**LEGAL ADVERTISEMENT
HISTORIC PRESERVATION BOARD
CITY OF PORTLAND
Public comments will be taken at all meetings**

On Wednesday, June 4, 2014 at 5:00 p.m., the Portland Historic Preservation Board will meet in Room 209 of City Hall to review the following items:

**HISTORIC PRESERVATION BOARD
CITY OF PORTLAND, MAINE**

**PUBLIC HEARING
1 CARROLL STREET**

MALIN ROW HOUSE
1 CARROLL ST. PORTLAND ME
PRELIMINARY DESIGN 02.11.14

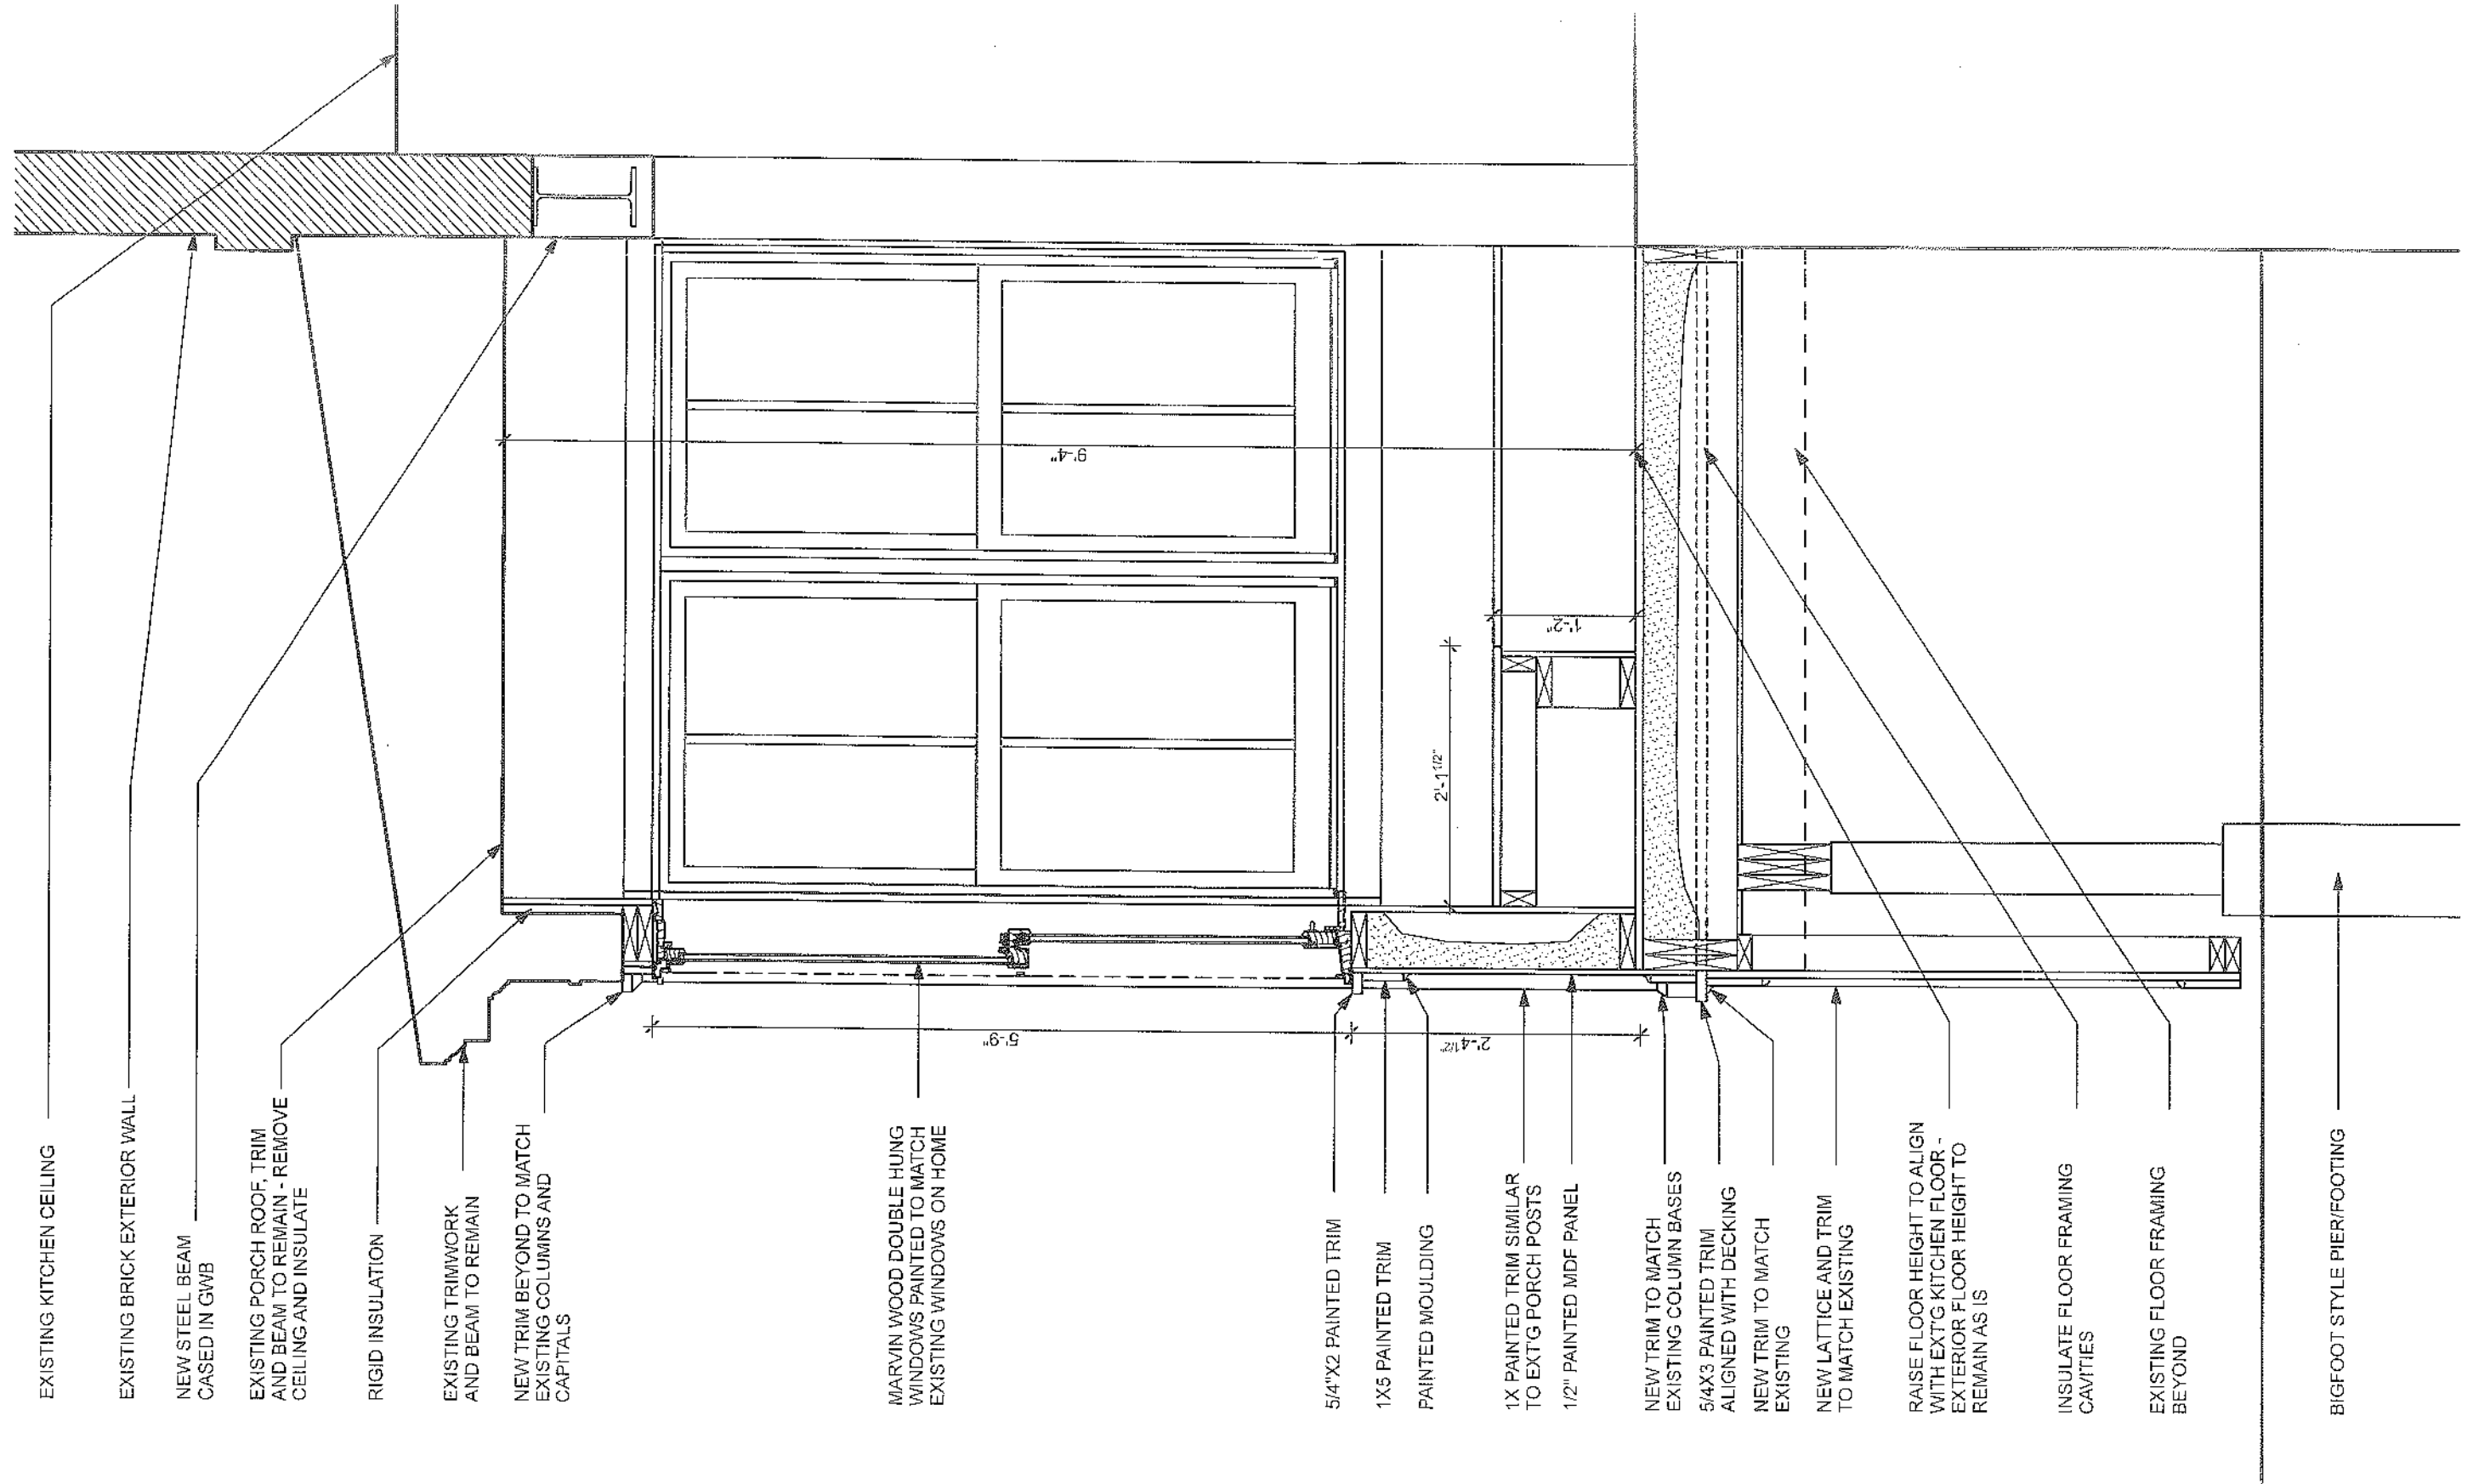
Mr. Whipple's description of the project revisions discusses a number of the points raised at the January 12 meeting, with the most notable design changes appearing on the east and north walls of the infill. The wall facing Thomas Street is more formal, with the addition of a central, full-height post and panels instead of clapboard below the windows. A panel also replaces clapboards on the south side, in the entry alcove. On the north side a series of panels is proposed, with the possibility of one them being replaced by an operable window. Little change is visible inside, except where posts are shown at the walls on either side where the exterior brick wall is to be removed.

The changes to the east and south elevations appear to be a positive response to the concerns raised at the January Board meeting. The exterior detailing is now both more robust and more formal, drawn from the character of the principal residence and differentiated from that of the garage.

In staff's view, the revised treatment for the north wall appears forced and incongruous—with or without the window option. Although the proposed treatment repeats the use of recessed panels featured on the other porch elevations, the panels are used in a non-traditional fashion and are visually distracting. The Board will want to discuss whether

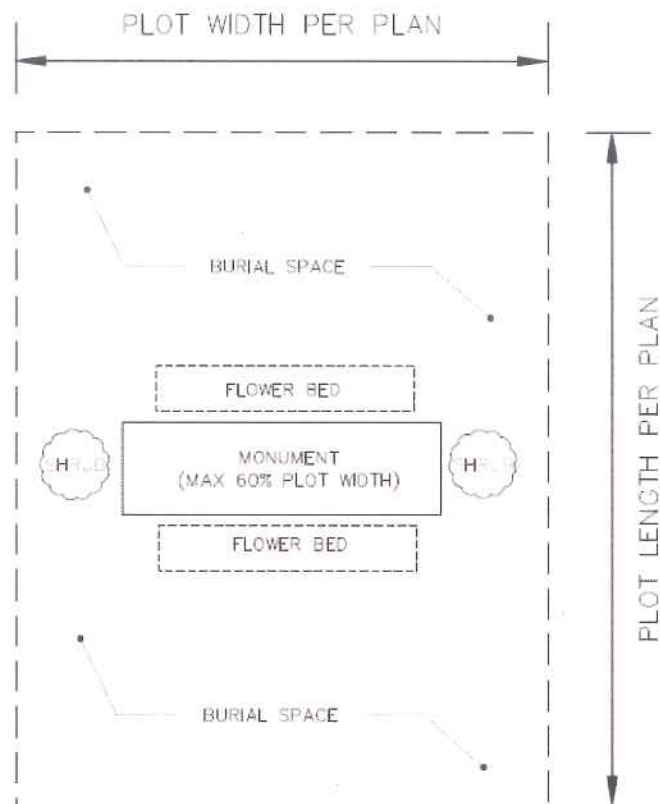
- Provisions for family plots within the expansion area. Board members were concerned that the grave sites identified as "potential family plots" on the submitted site plan did not provide

adequate assurance that these areas would be reserved for said use. Additionally, they noted that the way in which these areas were depicted on the map did not convey the fact that family plots often differ in configuration from standard burials—for example, family plots often include shrubs and an alternative layout of gravestones that provide visual interest and have the potential to build upon Evergreen's intended garden cemetery character.

Recognizing that it is impossible to define the exact configuration of future family plots on the plan, the Board nonetheless asked that the plan suggest the distinct character of these plots by showing them as areas defined by their overall dimensions. Board members also asked that further consideration be given to the percentage of family plots provided within the proposed expansion area. More information about the percentage of family plots within the historic section of the cemetery was also requested.

Response: The latest revised site plan shows the family plots as "reserved for family plots" and provides the square footage of each area. It also indicates the number of equivalent grave spaces accommodated by the area. In addition to the changes in the site plan itself, a sample family plot layout is provided which is intended to suggest the opportunity/recommendation for incorporating shrubs within the plot and a plan for grouping individual markers. While this plan is not intended to dictate the form of family plots, it does reinforce the intent to provide an alternative treatment.

We have updated the plans, showing 16 reserved family plot areas. The original grave layout has been removed from these areas, but the plan identifies the square foot area as well as the equivalent grave count for each family plot. The family plots vary in size from 4 equivalent grave spaces up to 10 equivalent grave spaces. The total equivalent grave count within the new family plots is 98, or approximately 3,800 square feet, representing approximately 12% of the total new grave layout proposed as part of this project. It is noted that throughout the rest of Evergreen Cemetery, there are 81 additional family plots available, representing a total of 450 equivalent graves.

① PERSPECTIVE FROM THE CORNER OF
BRACKETT AND WALKER STREET

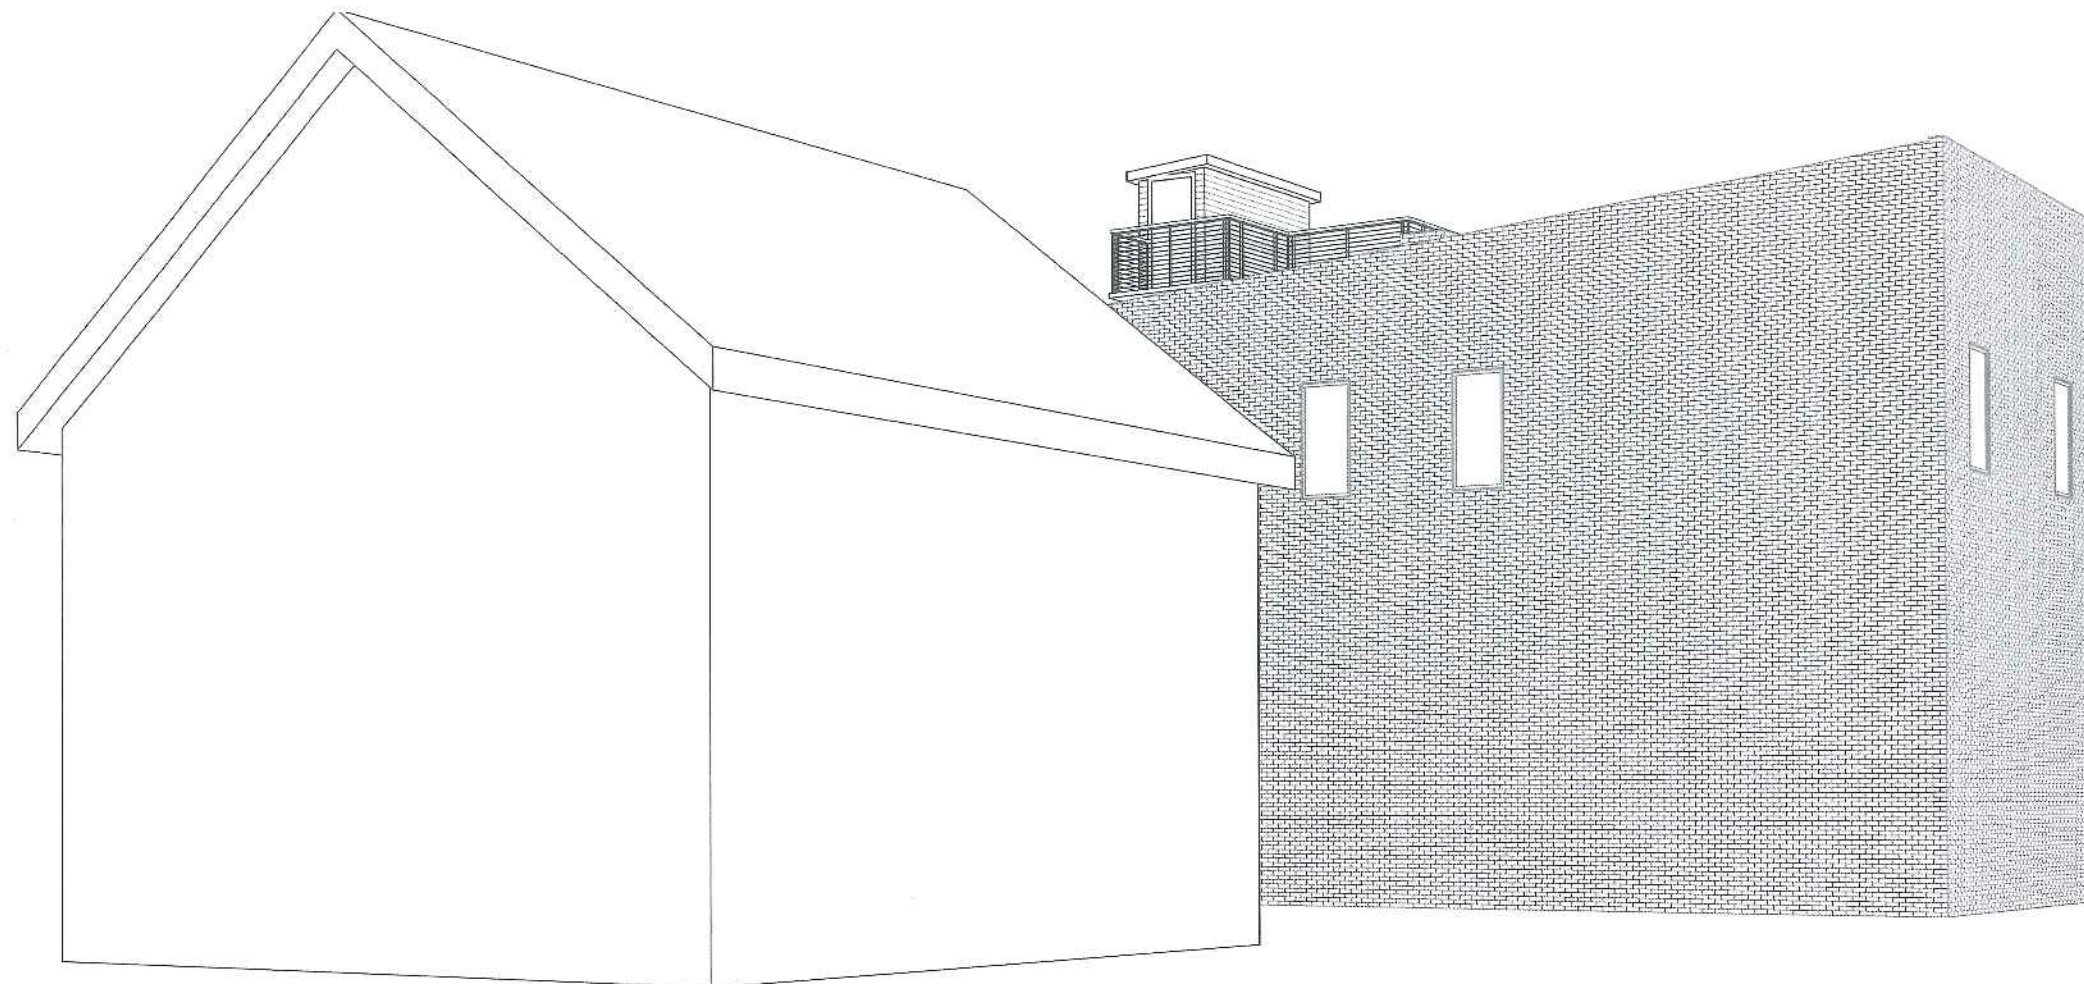
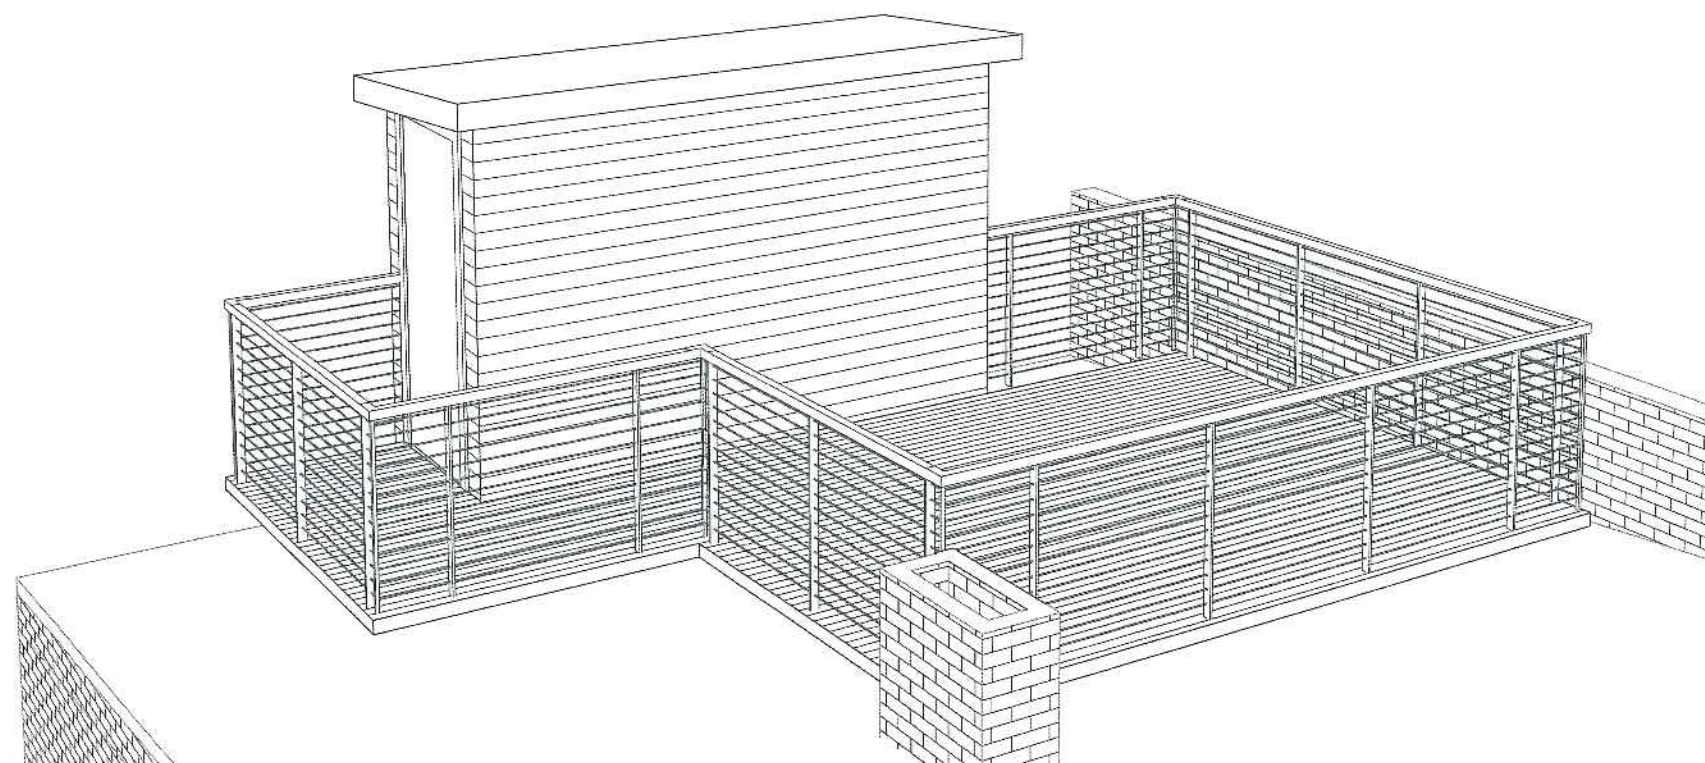
Note that the project architect has provided a perspective view of the proposed addition as seen from the corner of Brackett and Walker Streets—see Sheet A-5.1. This is likely the most prominent view of the proposed construction.

The questions before the Board are 1) whether the proposed rooftop addition negatively impacts the character-defining features of the historic structure; and 2) whether the addition is compatible with size, scale, material and character of the building. Provided the Board is reasonably supportive of adding a roof deck and penthouse in this context, staff suggests that consideration be given to eliminating the jog in the fencing. While this was done to reduce the amount of railing visible from the street, a simpler configuration might be preferable.
